STATE OF MAINE  
DEPARTMENT OF TRANSPORTATION  
16 STATE HOUSE STATION  
AUGUSTA, MAINE 04333-0016

August 9, 2018  
Subject: Wharf Infill & Building  
Removal  
State WIN: 021942.06  
Location: **Portland**  
**Amendment No. 3**

PORTLAND INTERNATIONAL MARINE TERMINAL  
MAINE INTERMODAL PORT PRODUCTIVITY PROJECT  
WHARF INFILL & BUILDING REMOVAL  
CUMBERLAND COUNTY  
PORTLAND  
**CONSTRUCTION PHASING PLAN**

PAVEMENT BOUNDARY MARKINGS AT RAMPS  
SCALE: N.T.S.

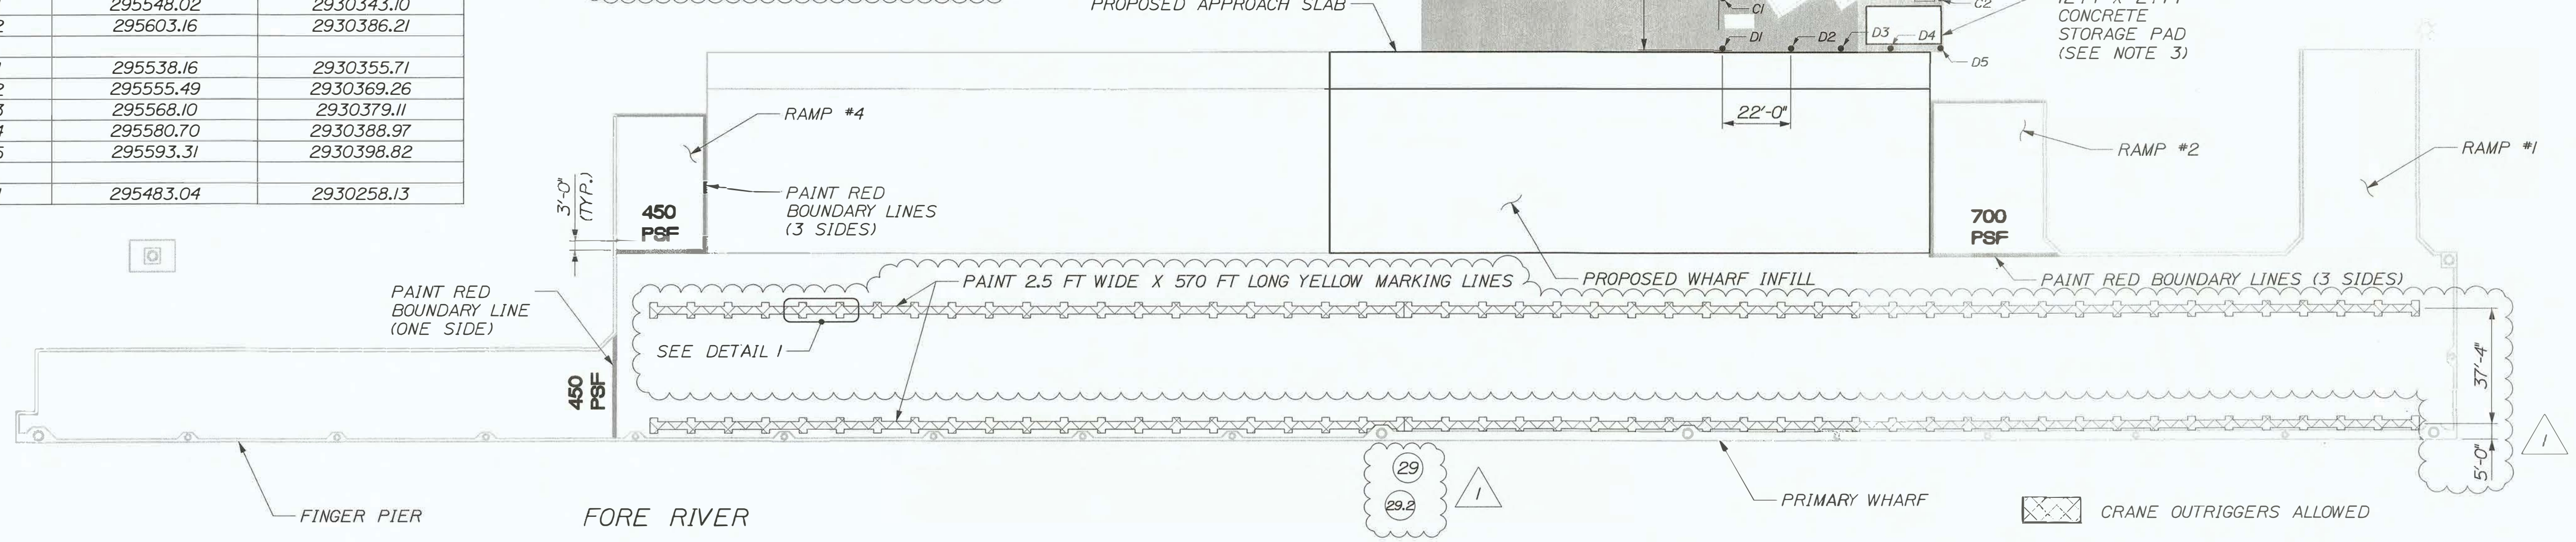
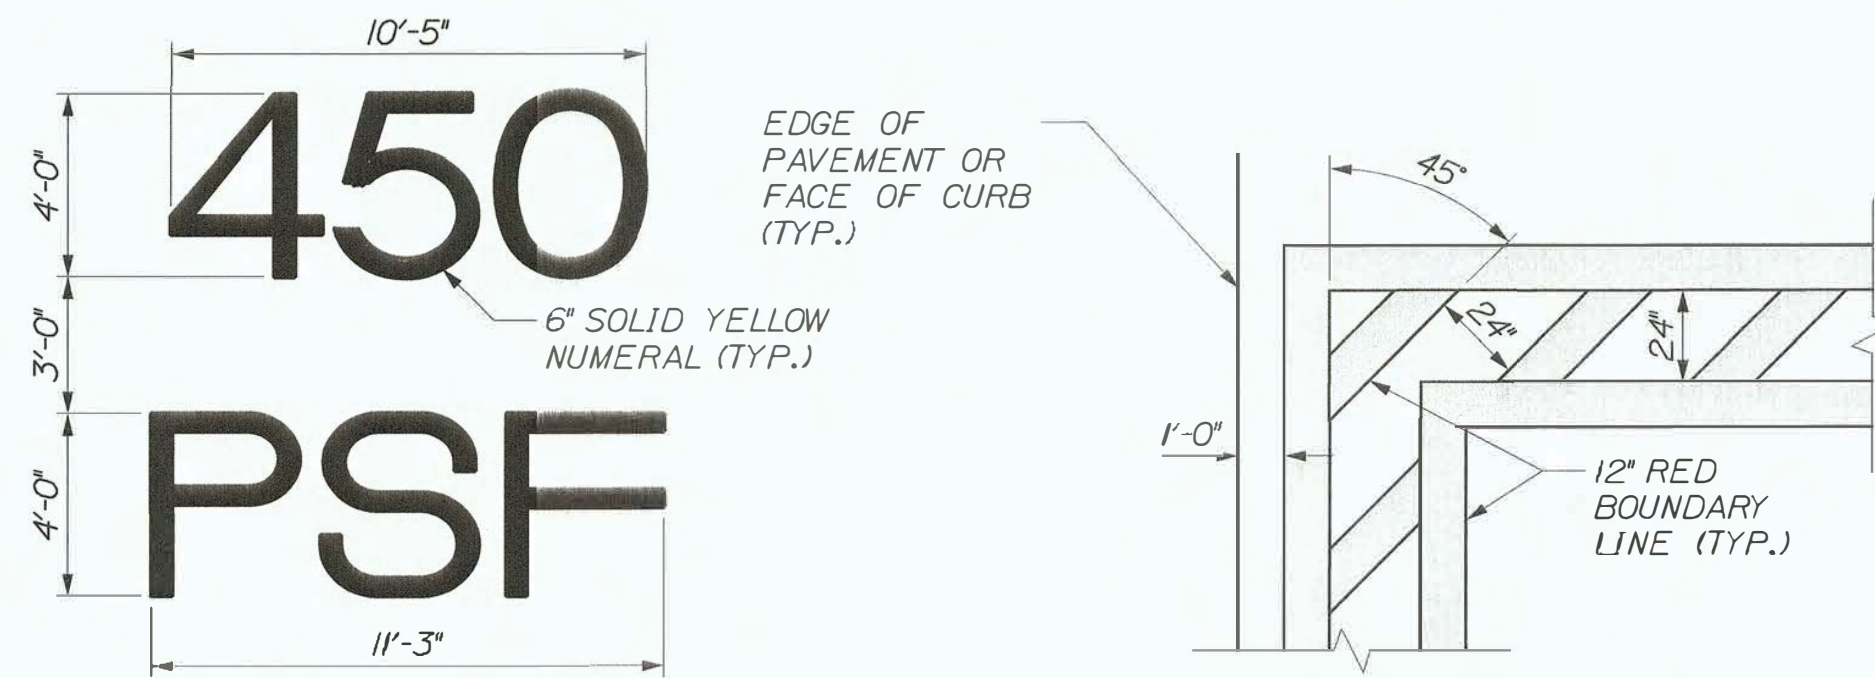
**Question:** Sheet CO 8 calls for painted yellow making line. Can you provide length of lines and dimensions of the pattern?

**Response:** There are two parallel lines on the deck, and each line shall be 2.5 feet wide and 570 feet long. There will be 49 tick marks on each line, and each tick mark shall correspond to the locations of the pile bents below the deck (typically spaced at 12 feet on-center). Tick marks shall be 2.5 feet wide by 5 feet long. At Bent No. 29, there are two bents side-by-side (Bent 29.2) which will also receive tick marks. Sheet C08 will be updated to illustrate these dimensions.

SHEET NUMBER  
**E01**  
 20A OF 21

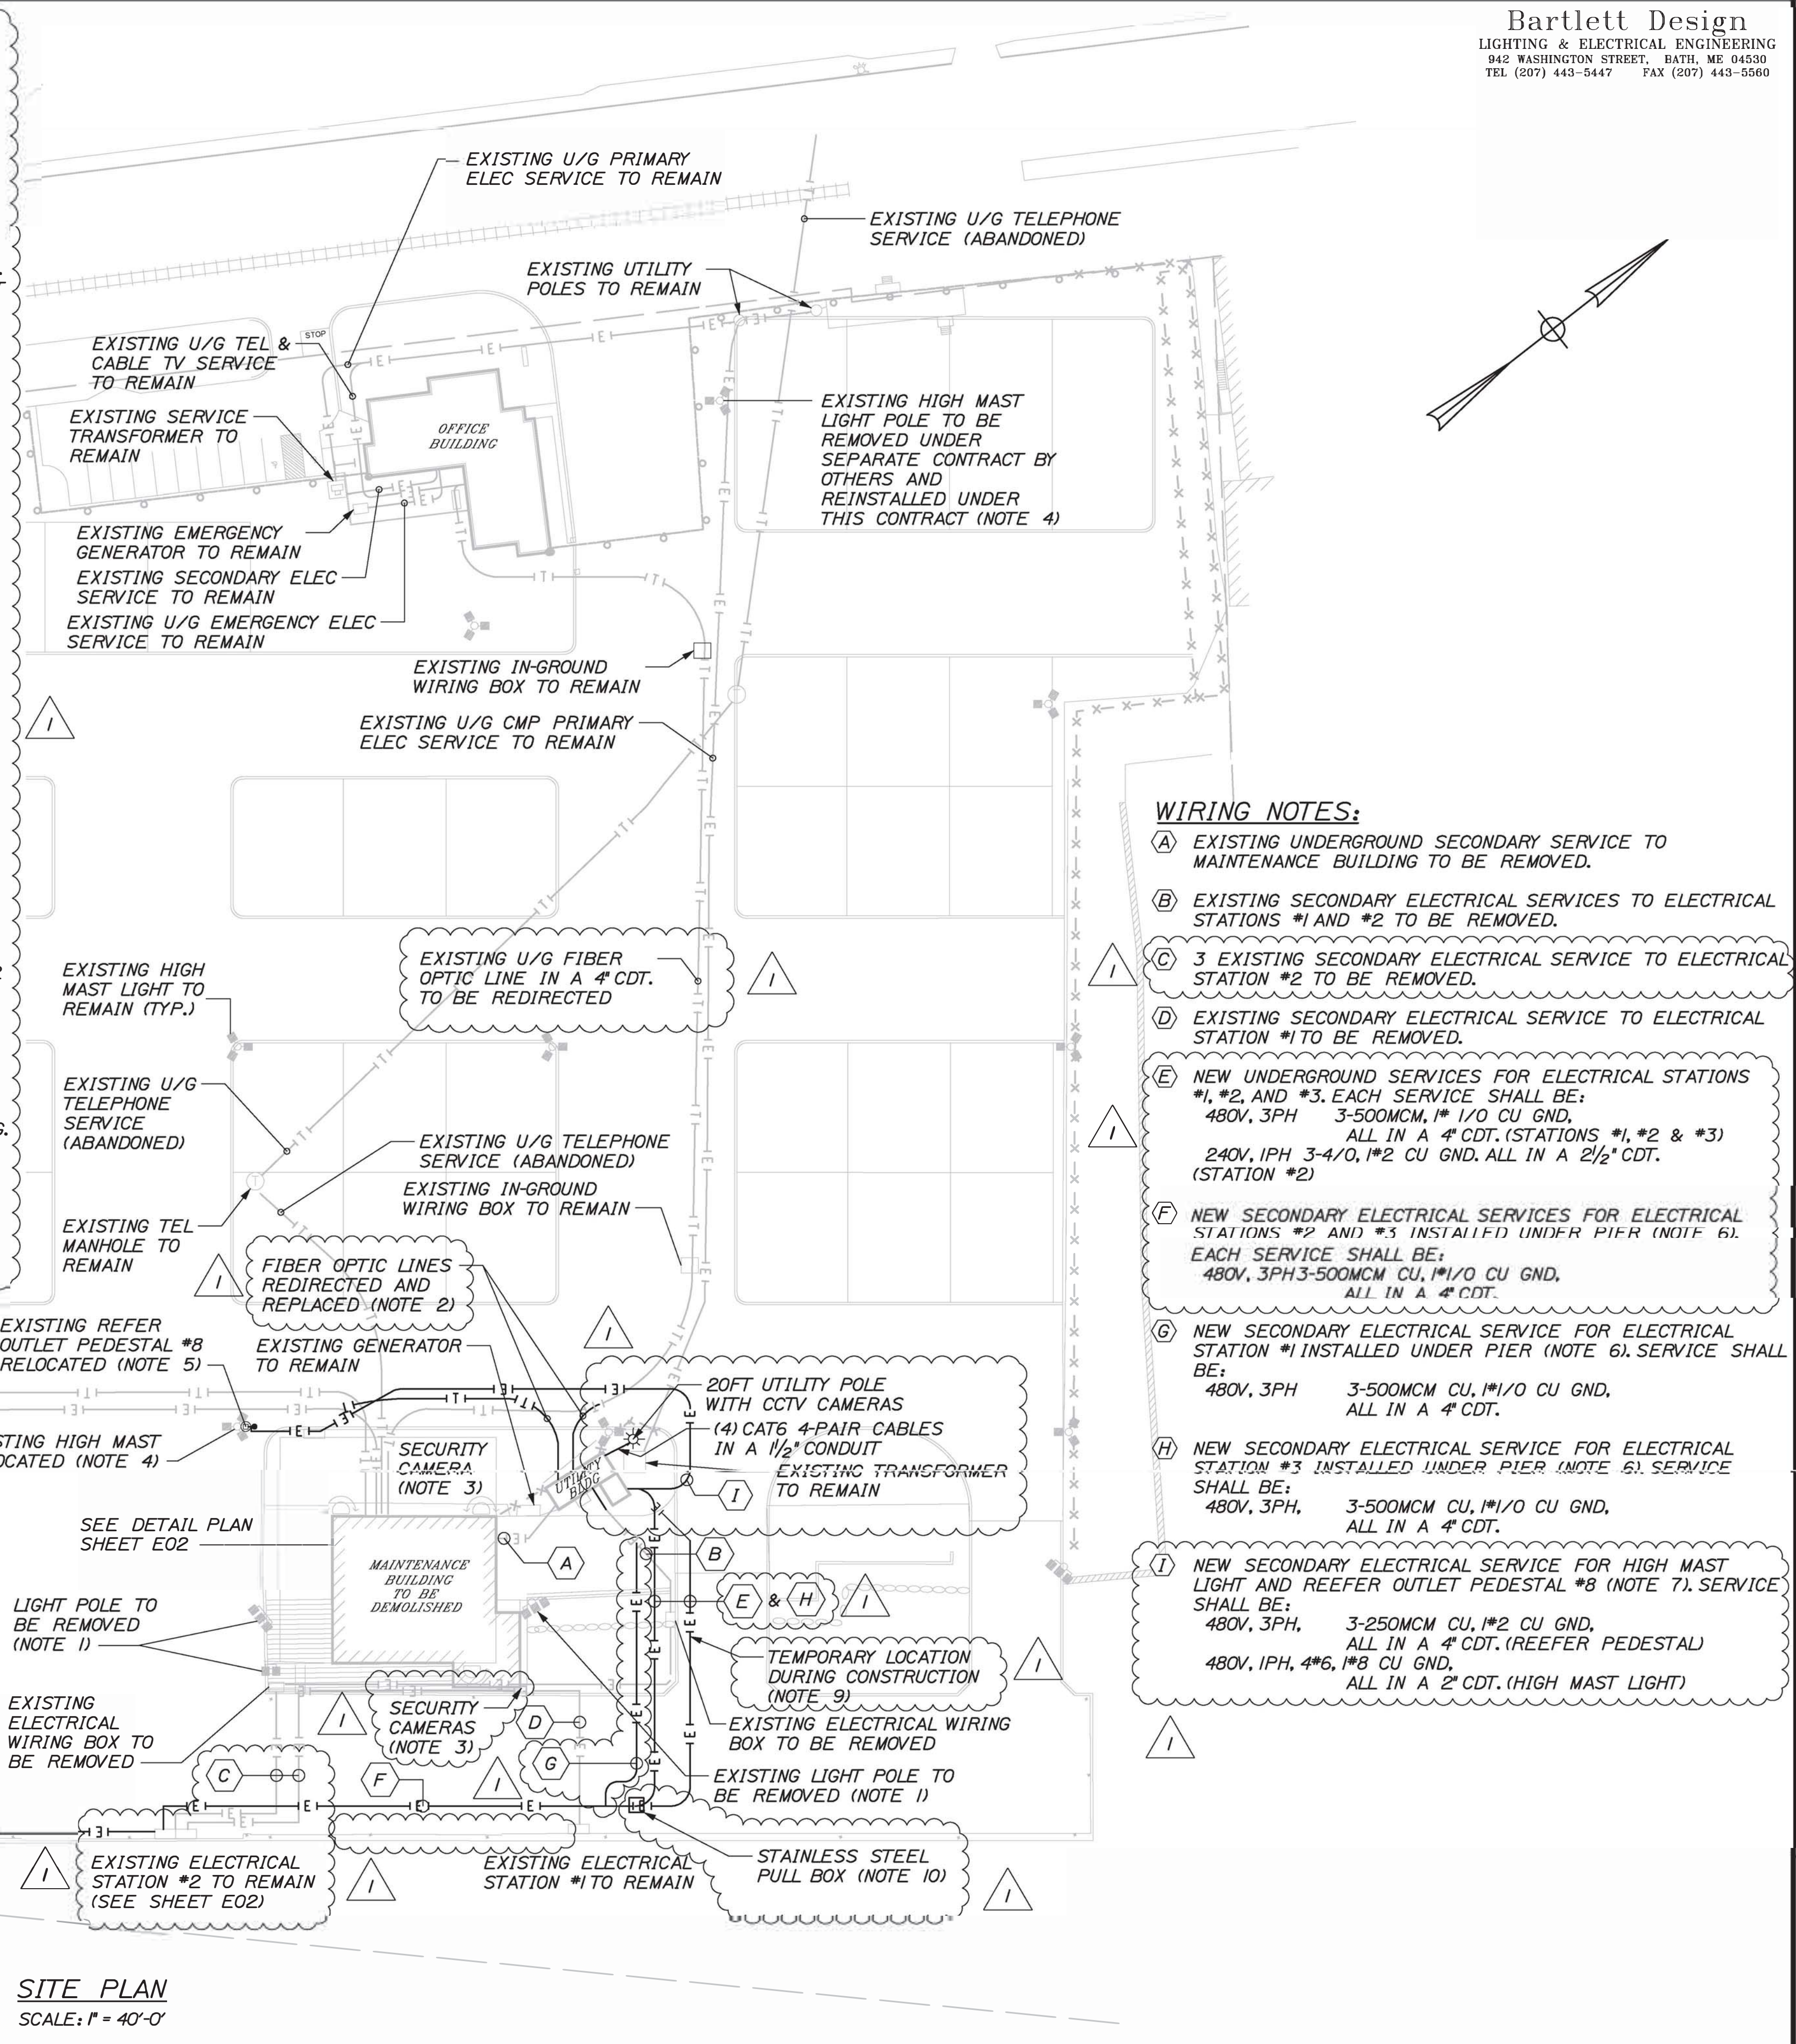
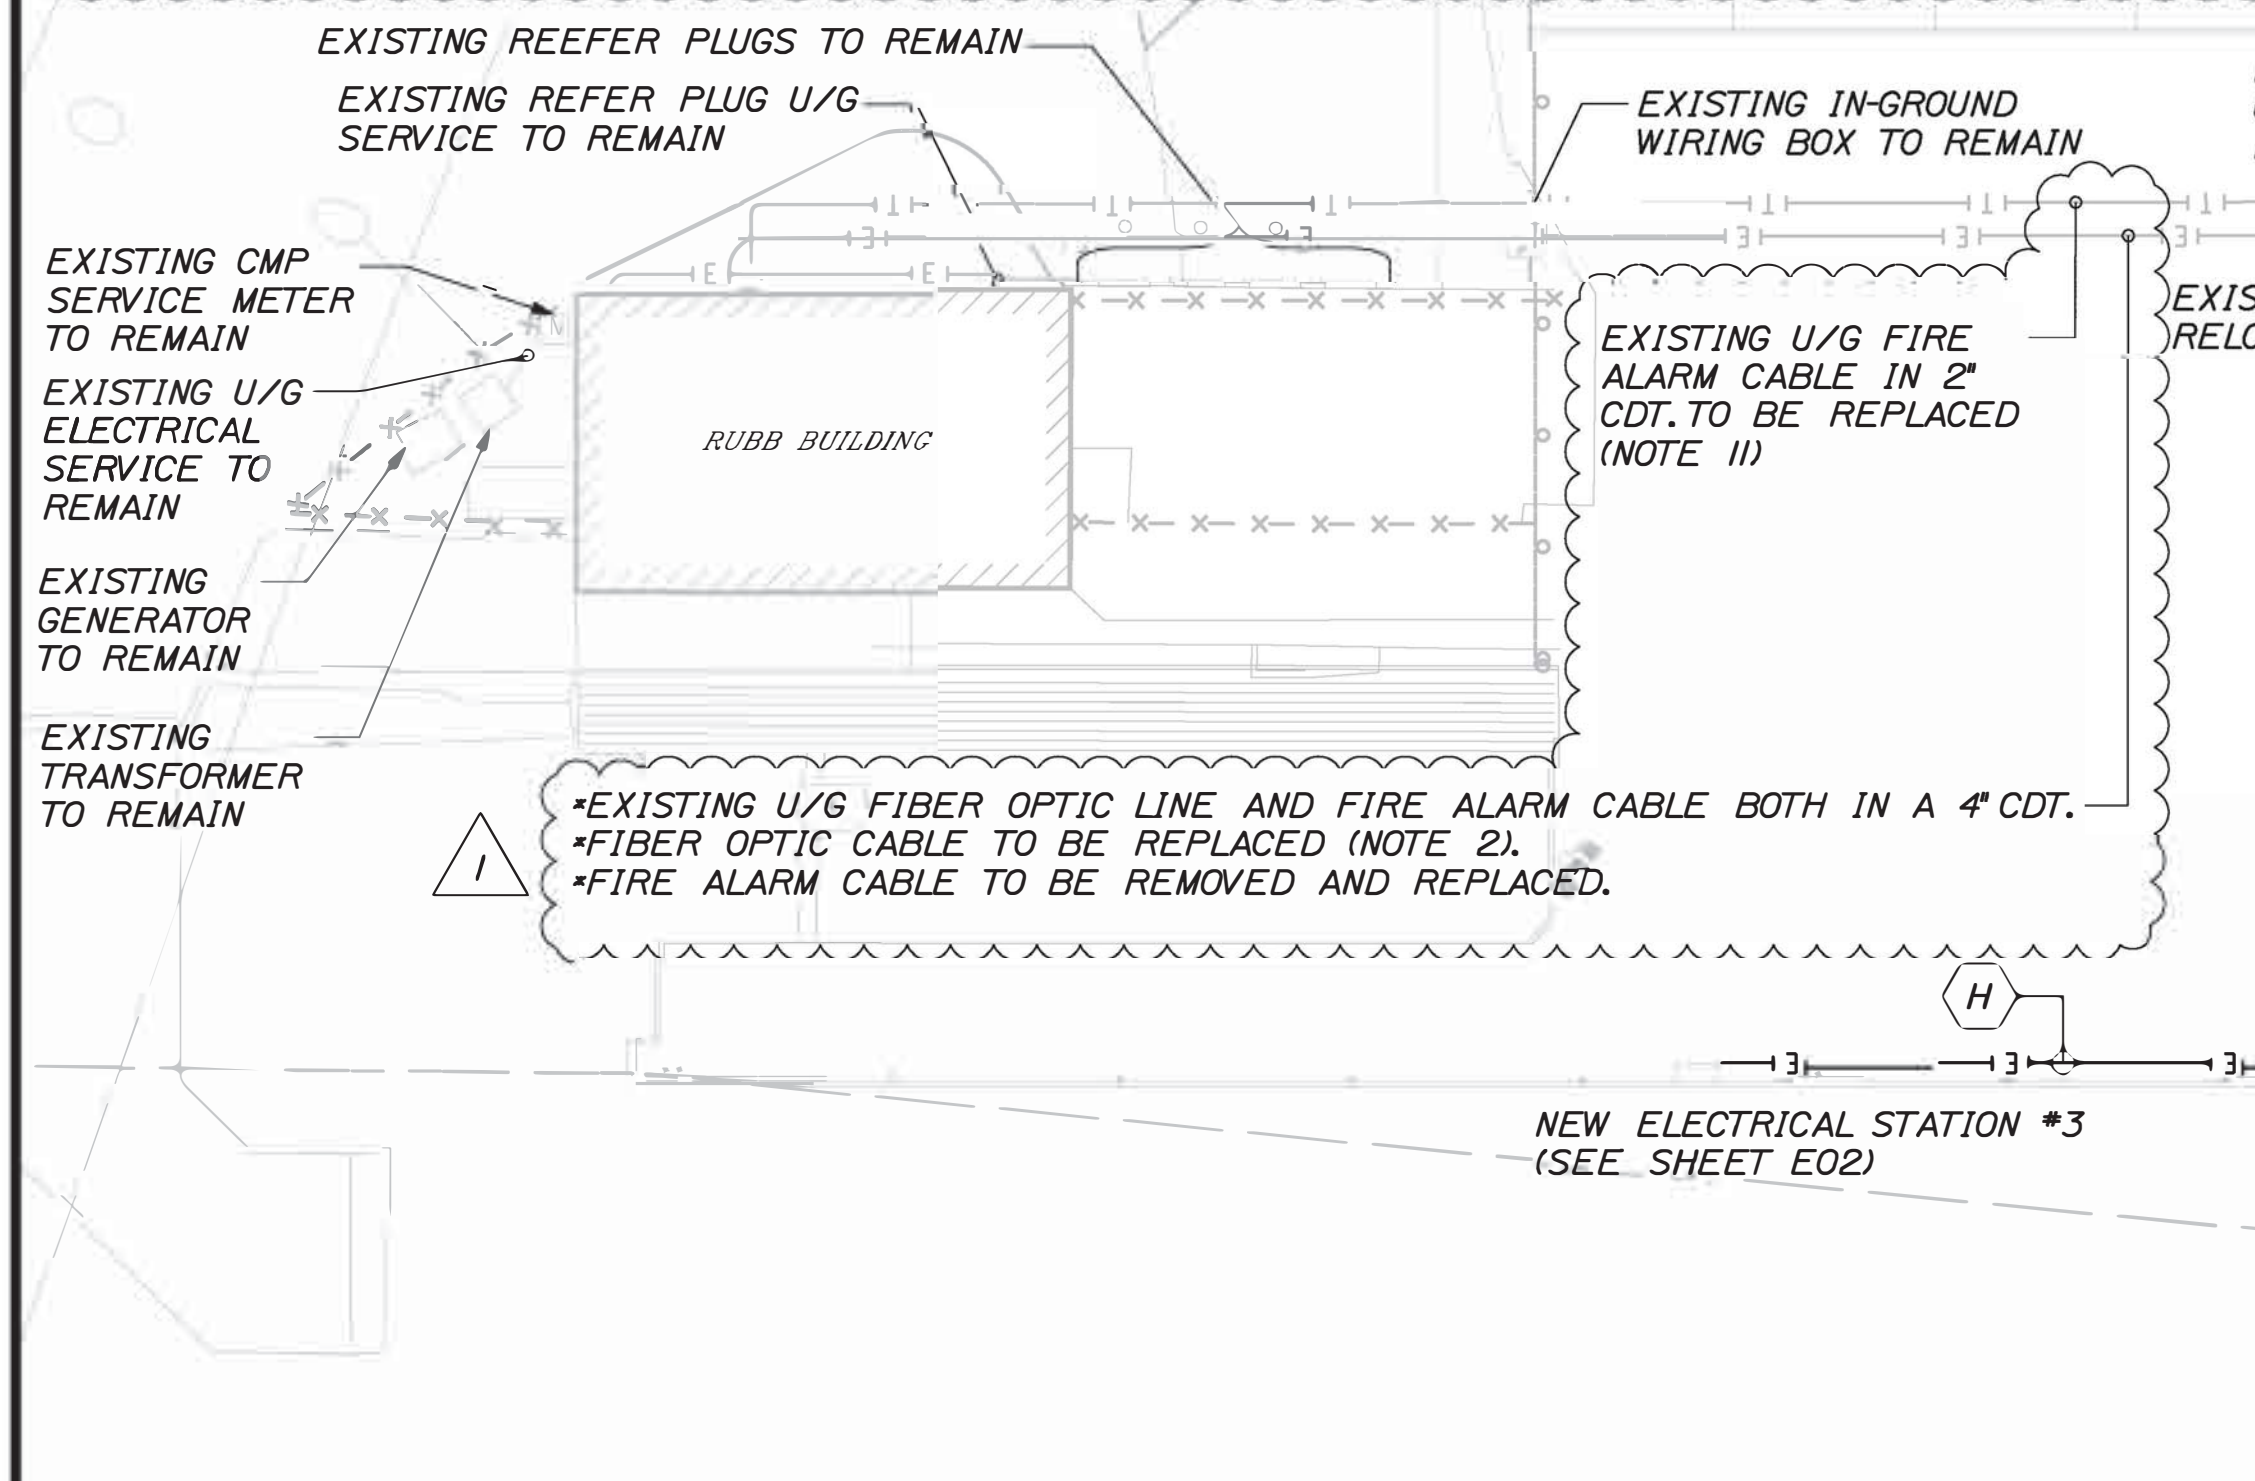
**Question:** Note 2 on Drawing E02 says replace 25A/3P breaker with new 400A/3P breaker in Siemens Panel PP-2. Need panel Manufacturer part number to quote new breaker.

**Response:** We do not have the exact model series of the existing breakers. The specifications call for the Contractor to provide compatible breakers. The Contractor should be able to obtain compatible breakers through the electrical distributor.
